LTB01060NAS1

# TECHNICAL BULLETIN

501-11: Glass, Frames and Mechanisms

## Power Windows Inoperative

E207685

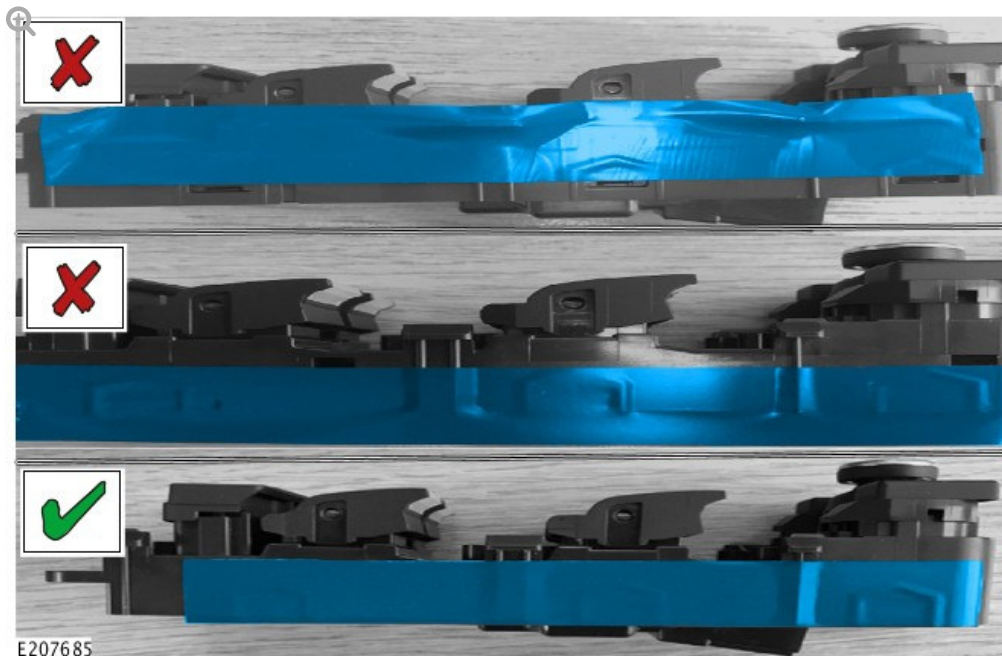
Apply sealing tape to both sides of the **new** driver door (master) window switchpack, covering the side cavities on the driver door switchpack.

Correct position (✓) of the sealing tape.
